#	DETAIL OF CHANGE(S)		REASON FOR CHANGES
1	Change of a Power Transformer in Power Supply Assy	1	To prevent flicker of picture

MODEL:SD-P5107

SERVICE INFORMATION

Date: Oct.13,2000 **No.:** SI-D01008 (1/2)
MODEL No. * **SER.No.** **S/M No.** **PG**

SIGNAL ASSY

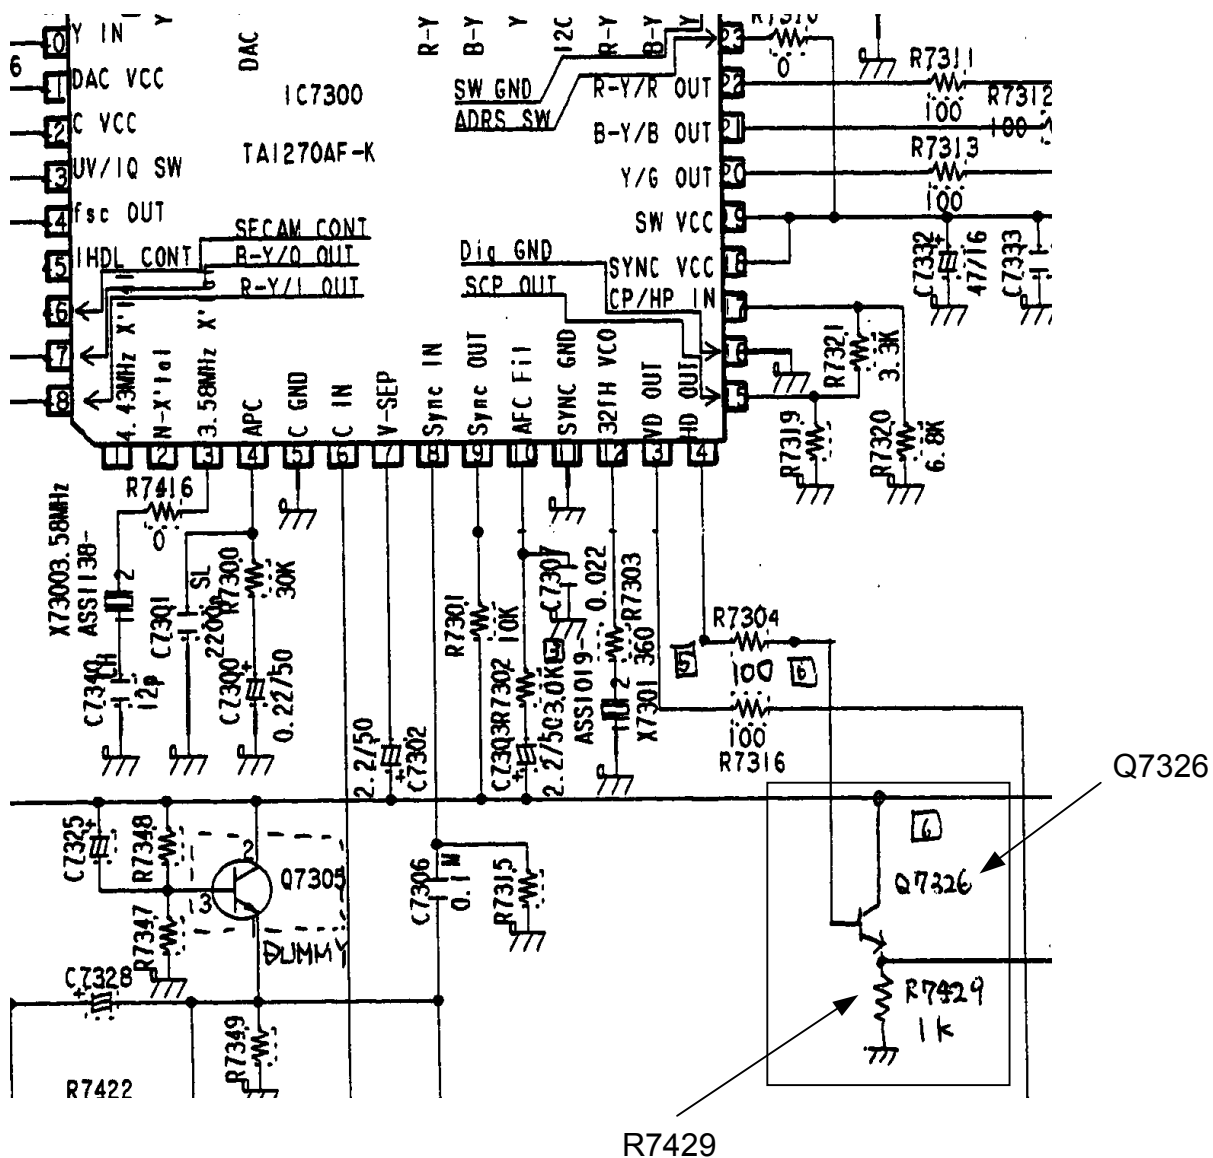
#	CHANGE
DETAIL	1	Addition of a resistor(R7429) and a transistor(Q7112)
	2	Addition of a transistor(Q7326)
	3	Change of a resistor(R7429 --> R7153 ---> R7429)
	4	Deletion of a transistor(Q7112)
REASON	1	To prevent the noise in 3-picture search mode.
	234	To prevent the noise in 3-picture search mode. (Production convenience)

Ref		CURRENT	PARTS	CO	NEW	PARTS
*	#	SYMBOL/DESCRIPTION	PART NUMBER	DE	PART NUMBER	SYMBOL/DESCRIPTION
A	1		Added	-	RD1/4PU102J	R7429
A	1		Added	-	2SC2712	Q7112
A	2		Added	-	2SC2712	Q7326
A	3	R7429	RD1/4PU102J	2	RS1/16S102J	R7153
A	3	R7153	RS1/16S102J	2	RS1/16S102J	R7429
A	4	Q7112	2SC2712	-	Deleted

MAIN POWER ASSY (AWR1077) PART'S VIEW

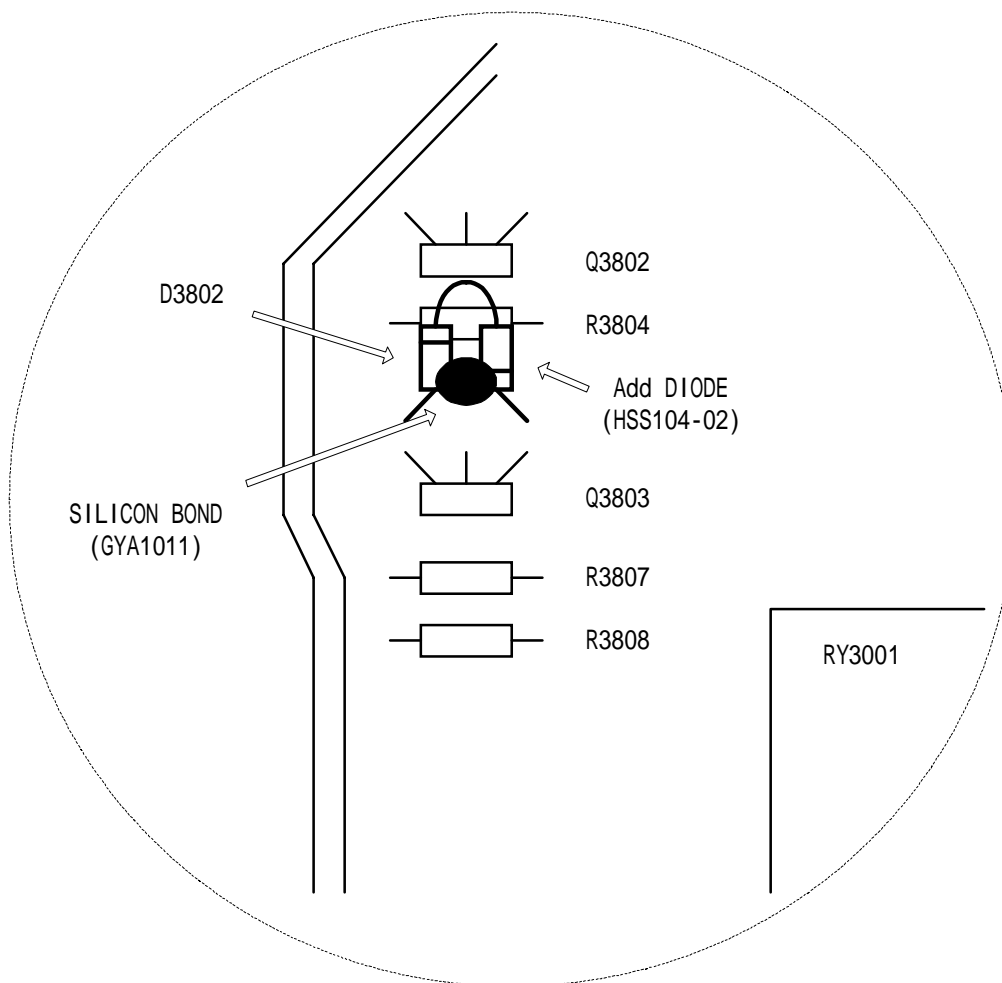
SERVICE
Remove the cathodic side of D3802, and add another diode (HSS104-02) to D3802 in series
REMEDY
in Main Power Assy (AWR1077).

*Please refer to Figure 1.

/ position of R3475,3476,3477 and R3405,3407,3408 (fig,1)

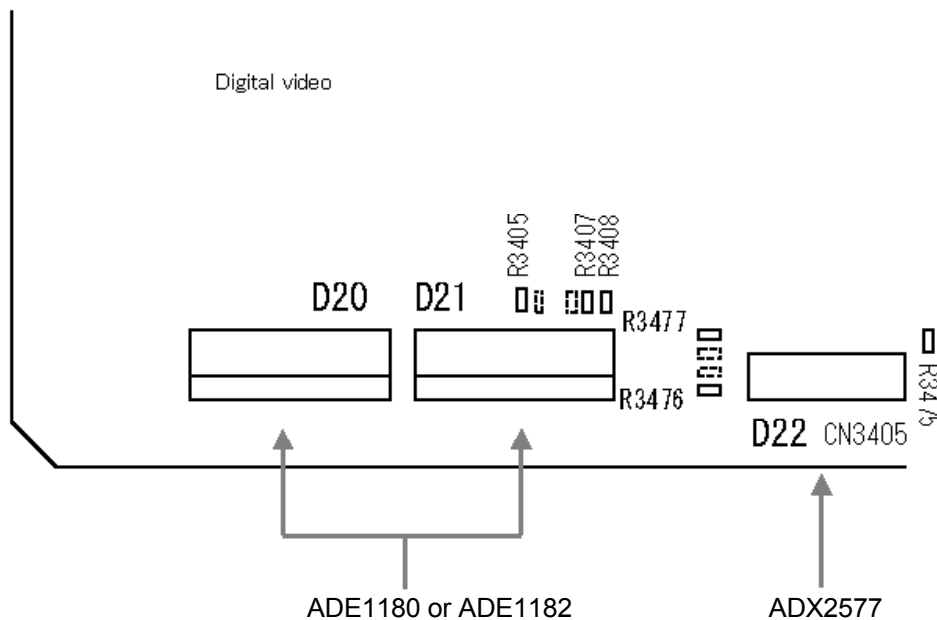
/ Remove resistors of R3475,R3476,R3477 and place them at location of R3405,R3407,R3408 when it is necessary.

R3405,3407,3408,3475,3476,3477 are same all resistor(10 ohms)

Parts location

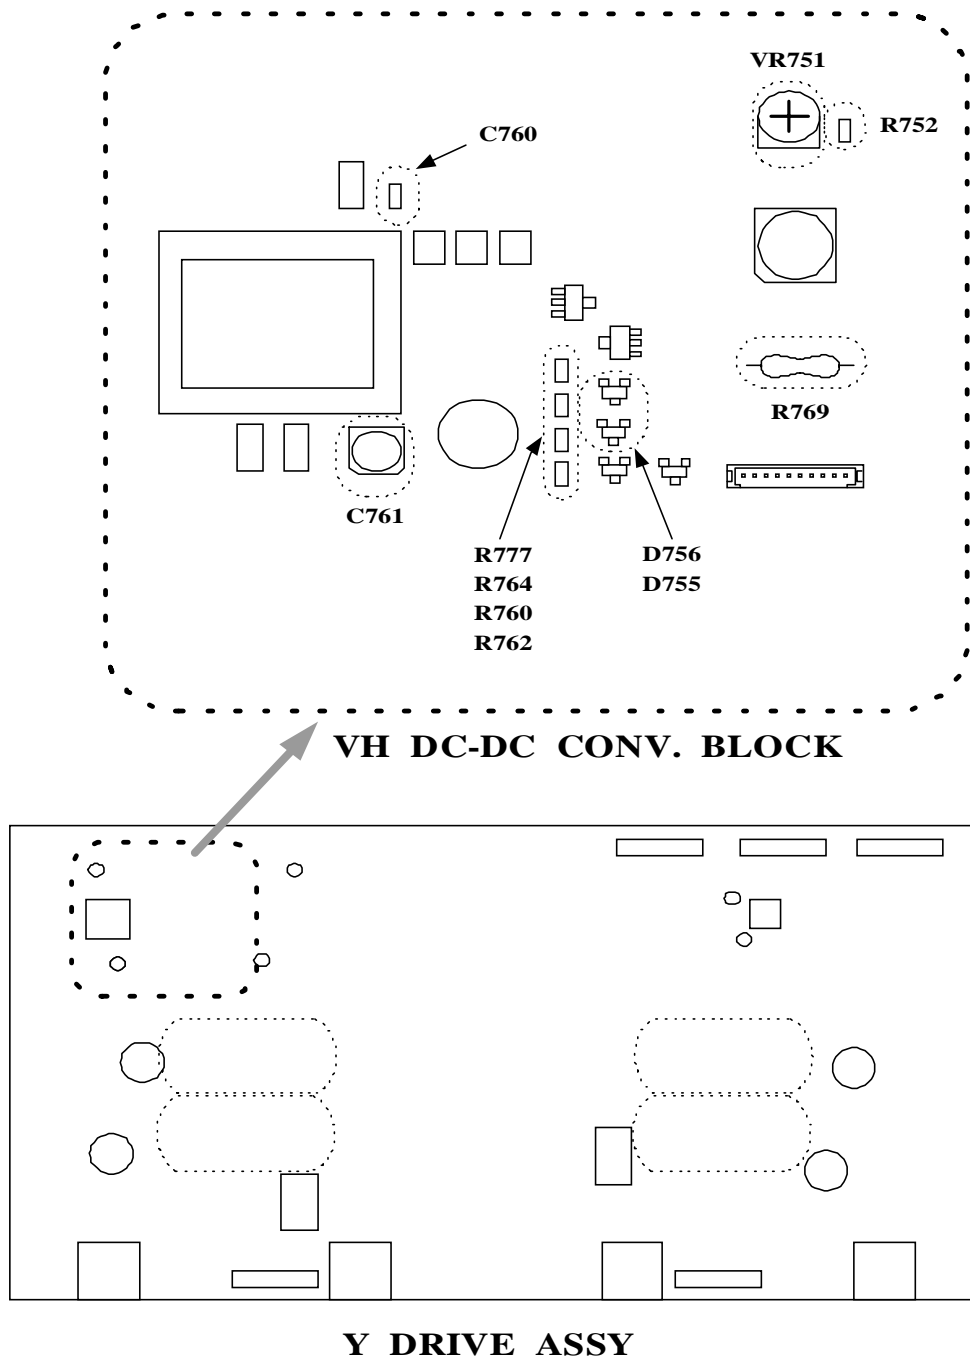
Modification of Vh DC-DC CONVERT BLOCK

- 1) Prepare a Service Parts Kit, **GXX1211**, consists of the following new parts
- 2) Replace old parts with new parts

OLD	NEW
R760, R762, R764, R777	RS1/10S1302F	RS1/10S1502F
VR751	VRTS6VS222	VRTS6VS102
R752	RS1/10S1201F	RS1/10S1101F
D755, D756	RD12MB	RD18MB
C760	CKSQYB104K25	CKSQYF104Z50
C761	CEHV101M16	CEHAT101M25
R769	RS2LMF153J	RS2LMF223J

Adeed place of SW Spacers

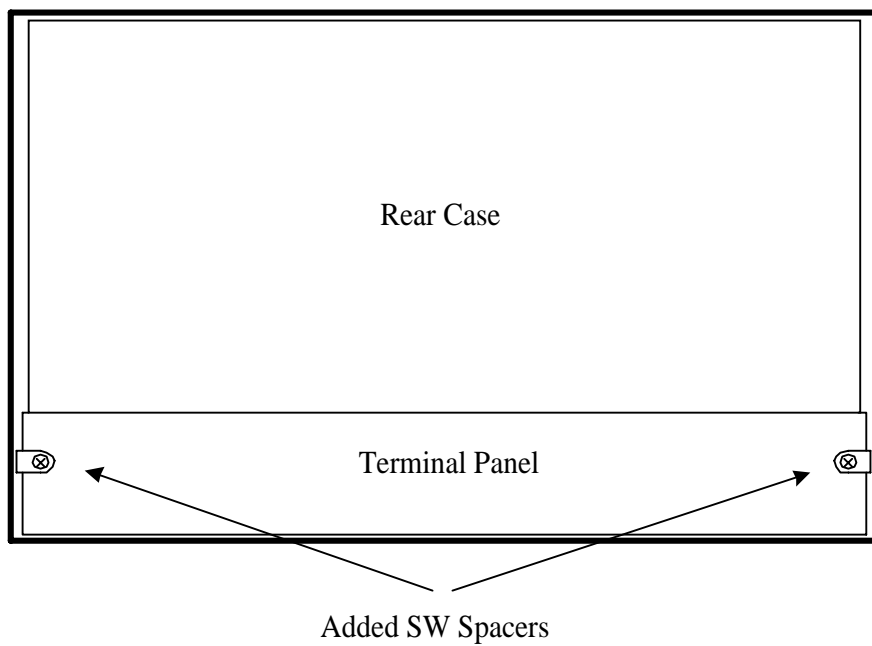
DETAIL # CHANGE
1 Added parts

REASON 1 To prevent Terminal Panel and Front Case being off from correct position.
(Because of the mis-assembling Main Power Button cannot work normally.)

Ref		CURRENT	PARTS	CO	NEW	PARTS
*	#	SYMBOL/DESCRIPTION	PART NUMBER	DE	PART NUMBER	SYMBOL/DESCRIPTION
A	1		Added	-	AMR3371	SWspacer

Changed VR5001, R5019

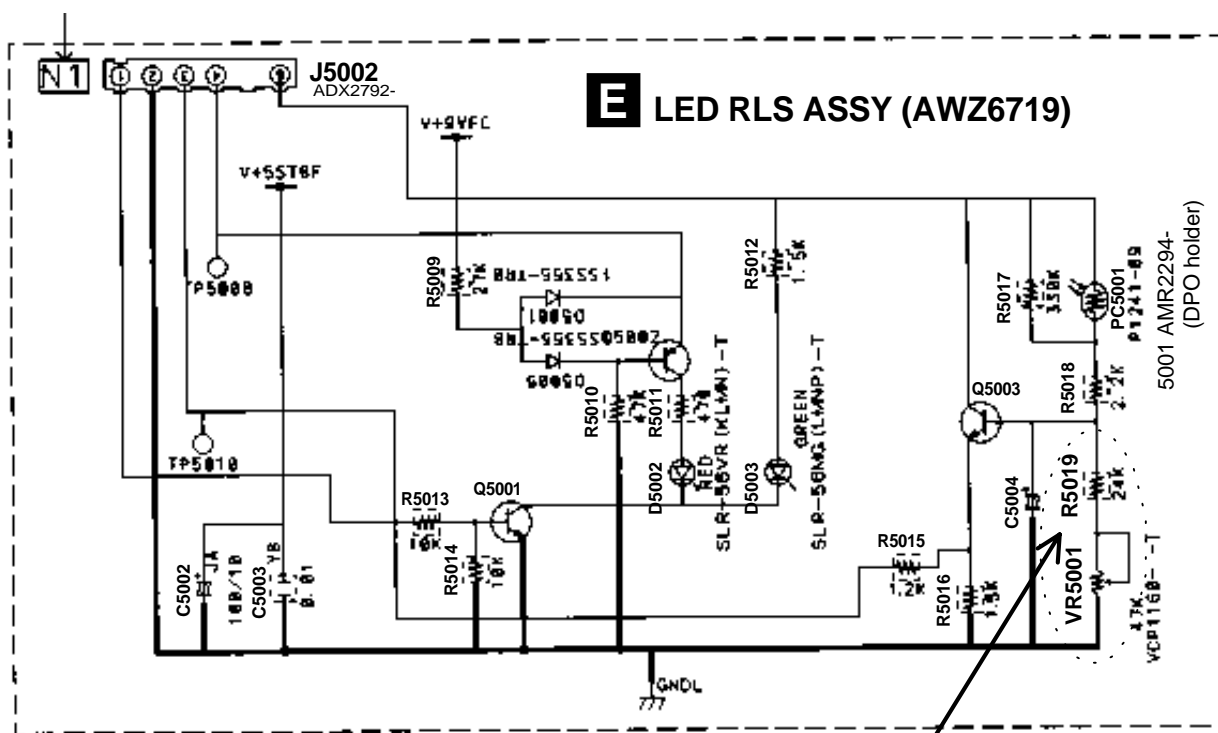
DETAIL # **CHANGE**
1 Changed parts in LED RLS ASSY, AWZ6719

The position of the added sheet

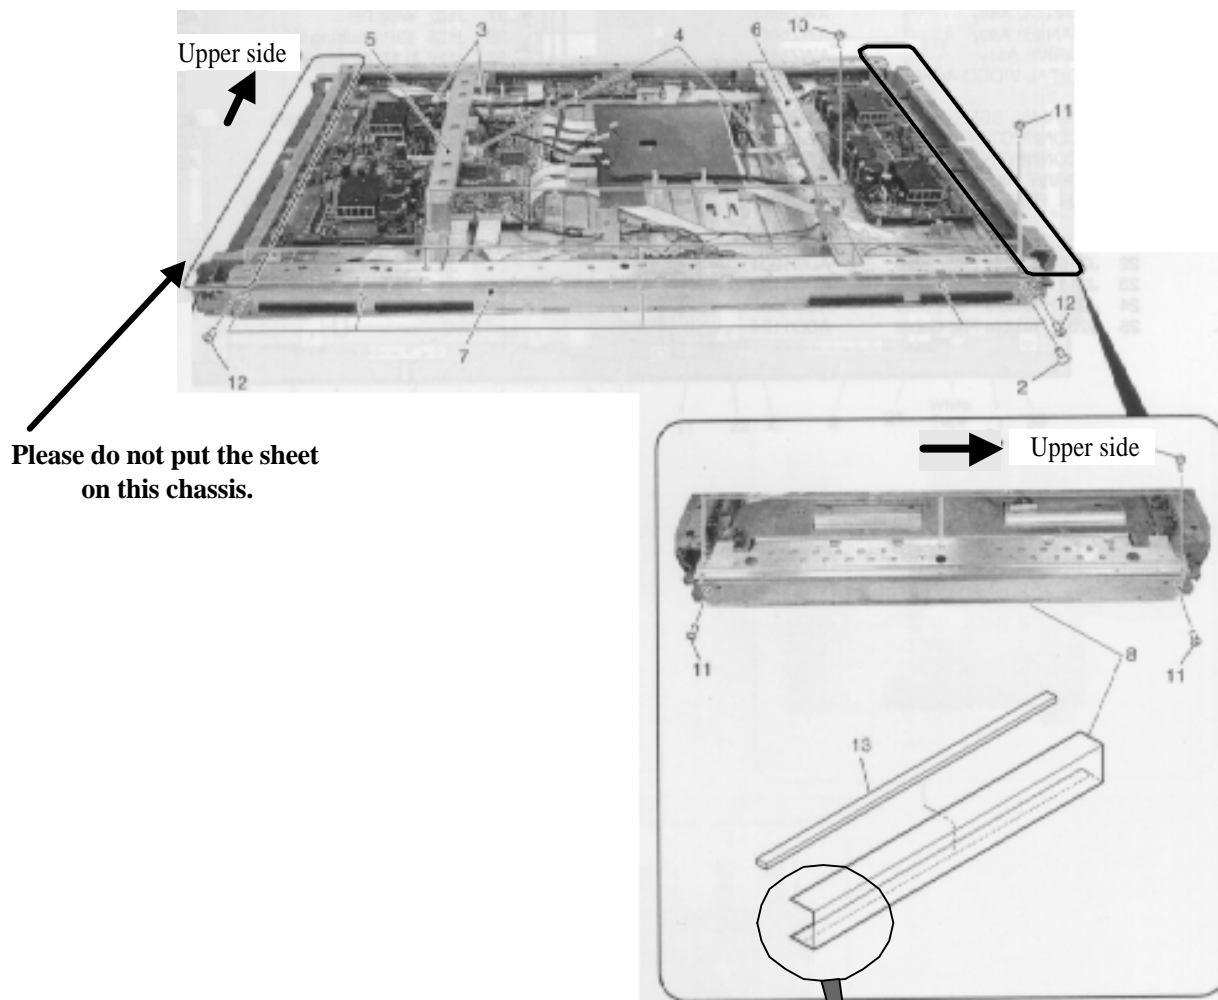
DETAIL # **CHANGE**
1 Added the anti-vibration sheet C (AEC1927).

Please put the sheet along the corner of front chassis V.

Please put the sheet to the edge of square hole.

Ref		CURRENT	PARTS	CO	NEW	PARTS
*	#	SYMBOL/DESCRIPTION	PART NUMBER	DE	PART NUMBER	SYMBOL/DESCRIPTION
A	1		Added	-	AEC1927	Anti-Vibration Sheet C

Exploded view of Panel chassis

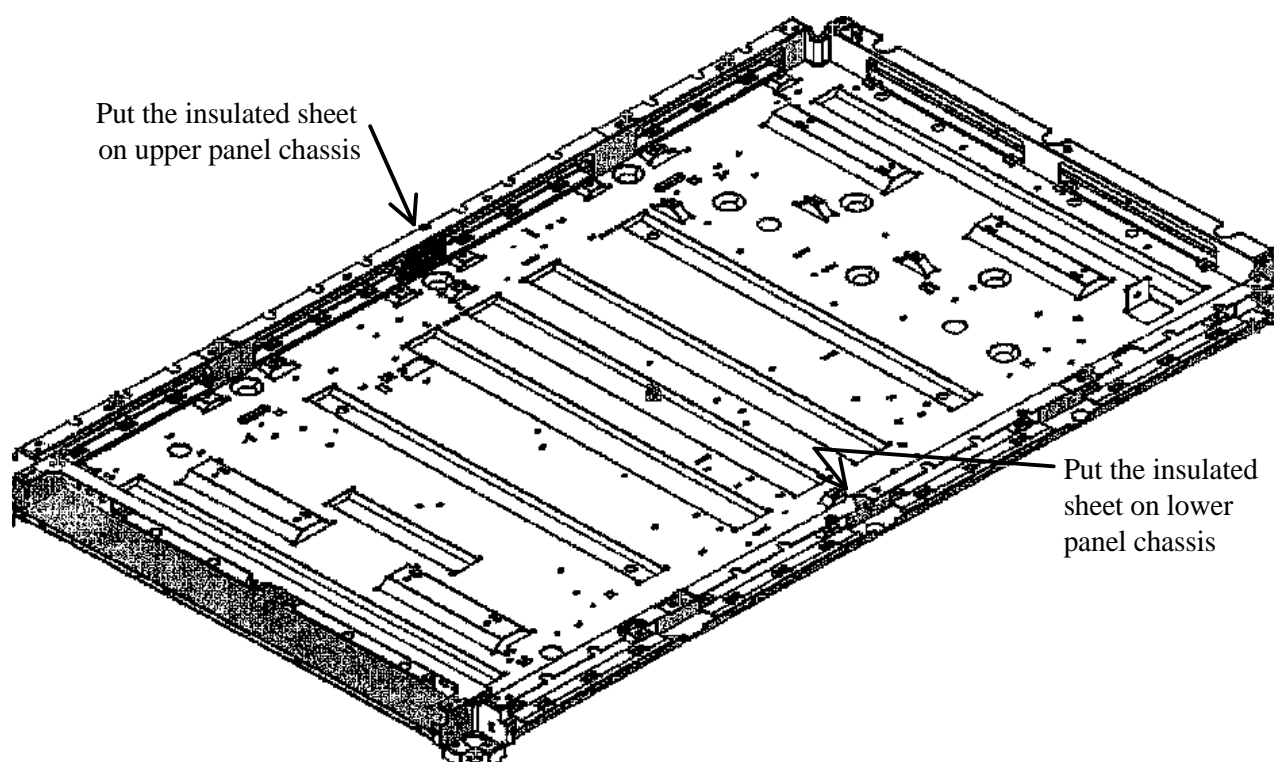
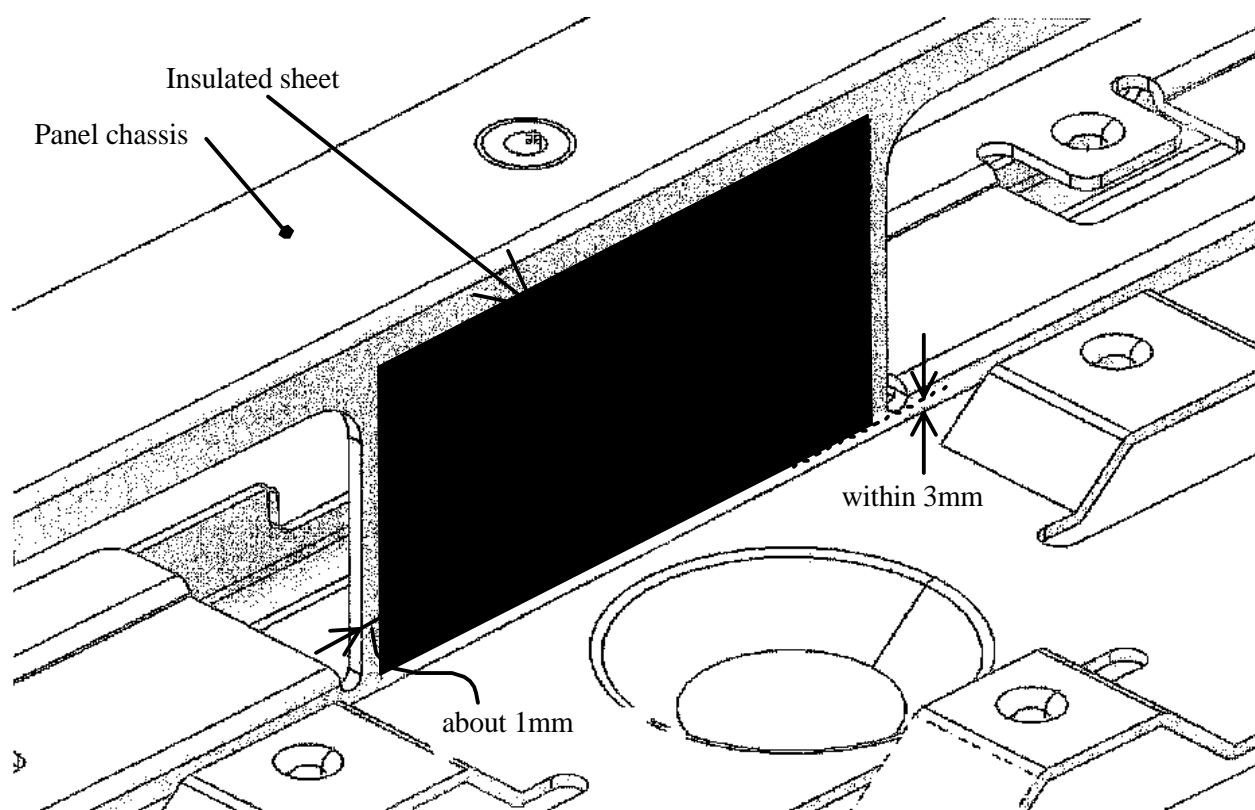
2 Put insulated sheet on both upper and lower panel chassis. Refer to the exploded views.
And furthermore, if the PDP you are fixing is an industrial model, put insulated sheet on RGB Base also.

SYNC DET BLOCK

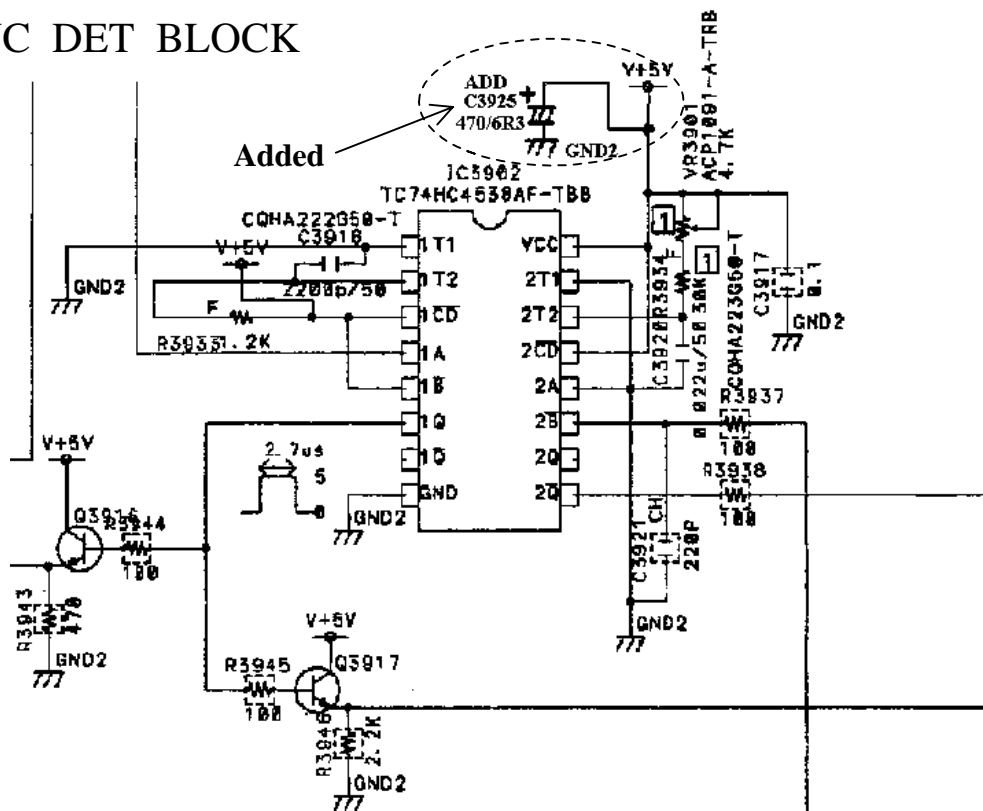
DETAIL	#	CHANGE
	1	Additon of capaitor in SIGNAL Assy (AWV1891)

REASON 1 Reduce crosstalk

Ref	CURRENT	PARTS	CO	NEW	PARTS
* #	SYMBOL/DESCRIPTION	PART NUMBER	DE	PART NUMBER	SYMBOL/DESCRIPTION
A 1		Added	-	CEAT471M6R3	C3925

SIGNAL ASSY (AWV1917) COMPONENT BLOCK

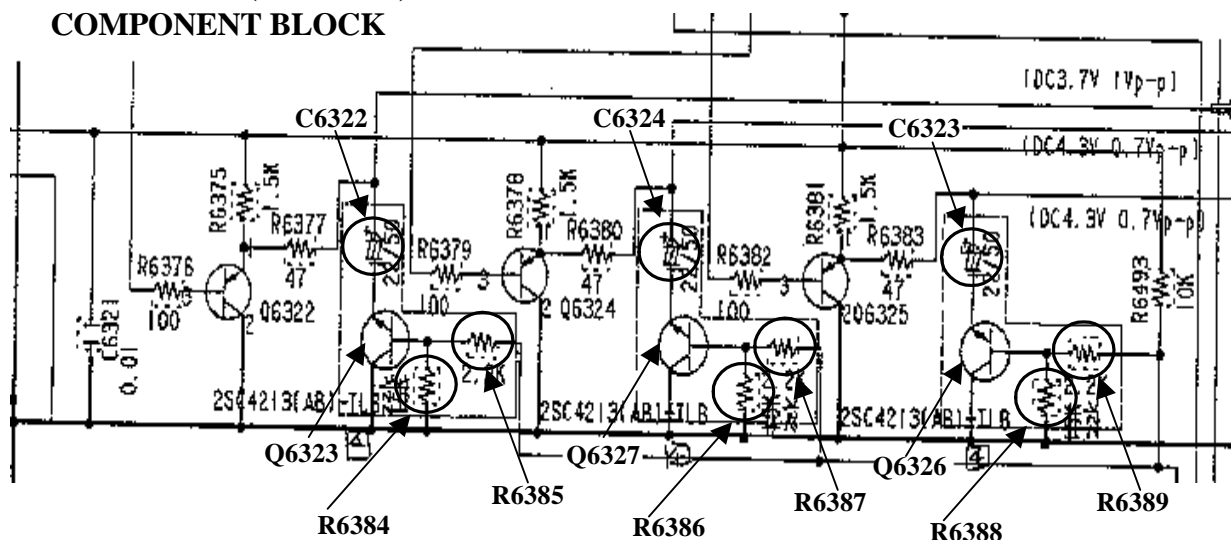
REASON 1 To prevent crosstalk.

Ref	CURRENT	PARTS	CO	NEW	PARTS
* #	SYMBOL/DESCRIPTION	PART NUMBER	DE	PART NUMBER	SYMBOL/DESCRIPTION
A 1		Added	-	RS1/16S223J	R6384, R6386, R6388
A 1		Added	-	RS1/16S222J	R6385, R6387, R6389
A 1		Added	-	2SC4213	Q6323, Q6326, Q6327
A 1		Added	-	CEAT220M50	C6322, C6323, C6324
